Product Change Notification - SYST-28KGMN085

Data Sheet - SY100EL16V-5V/3.3V ECL Differential Receiver Data Sheet

SYST-28KGMN085 - Data Sheet - SY100EL16V-5V/3.3V ECL Differential Receiver Data Sheet

3.1 Package Marking Information

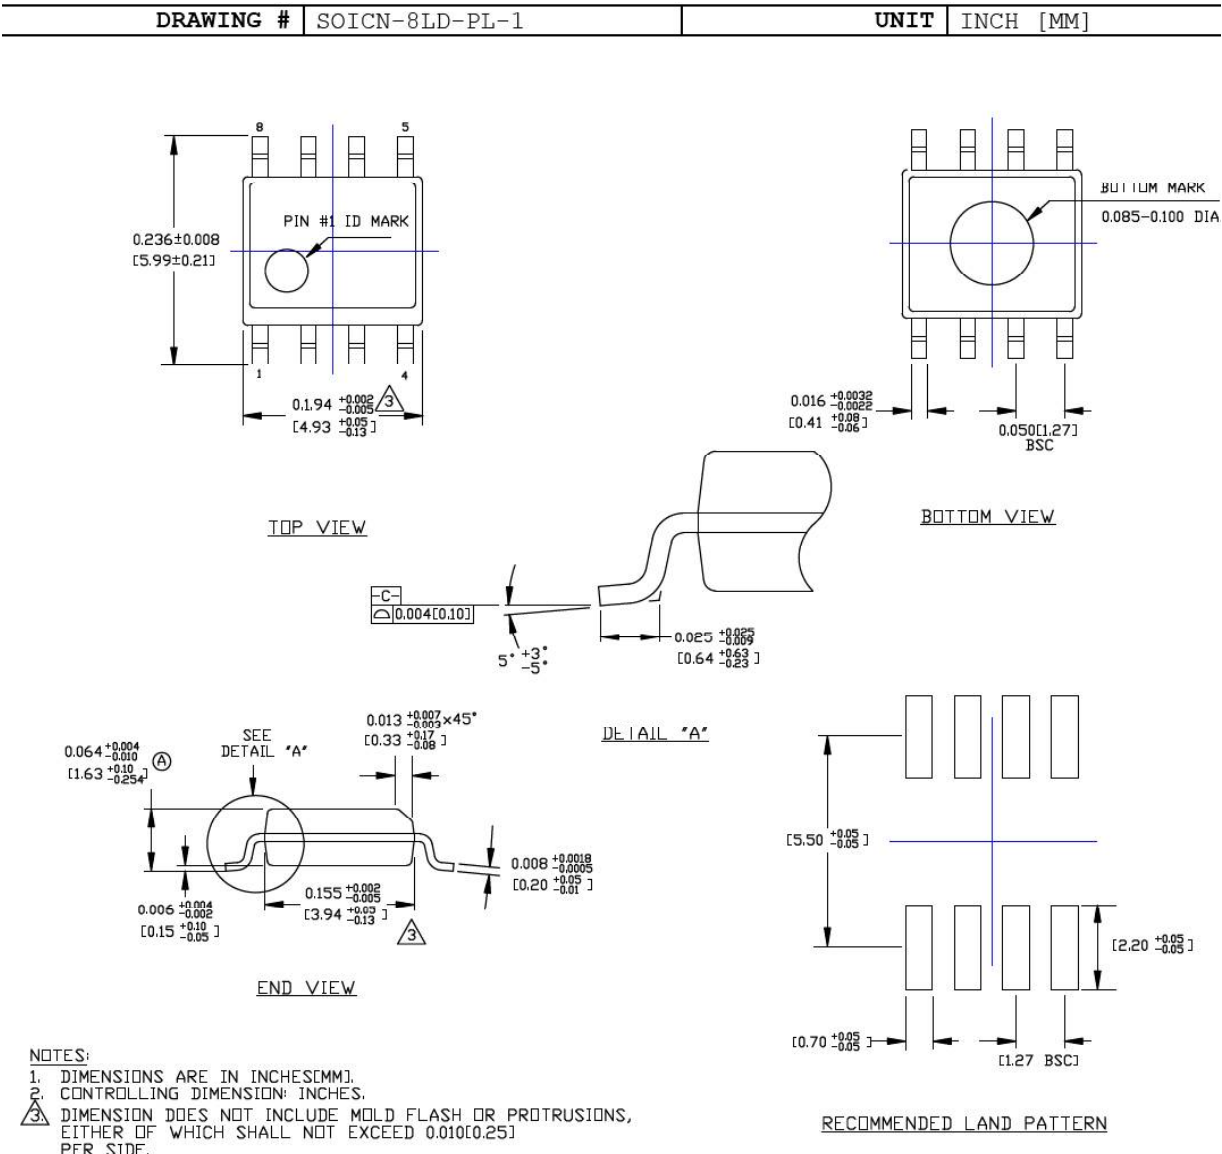
- 1) Updated minimum values for Common Mode Range voltage in PECL DC Electrical Characteristicstable and NECL DC Electrical Characteristics table.
- 2) Minor stylistic updates to align data sheet with current style.
- 3) Added Marking Spec for MSOP Package Option in Section 3.1 “Package MarkingInformation”.
- 4) Added MSOP examples to the Product Identification System section.

- Updated minimum values for Common Mode Range voltage in [PECL DC Electrical Characteristics](#) table and [NECL DC Electrical Characteristics](#) table.
- Minor stylistic updates to align data sheet with current style.
- Added Marking Spec for MSOP Package Option in **Section 3.1 “Package Marking Information”**.
- Added MSOP examples to the [Product Identification System](#) section.
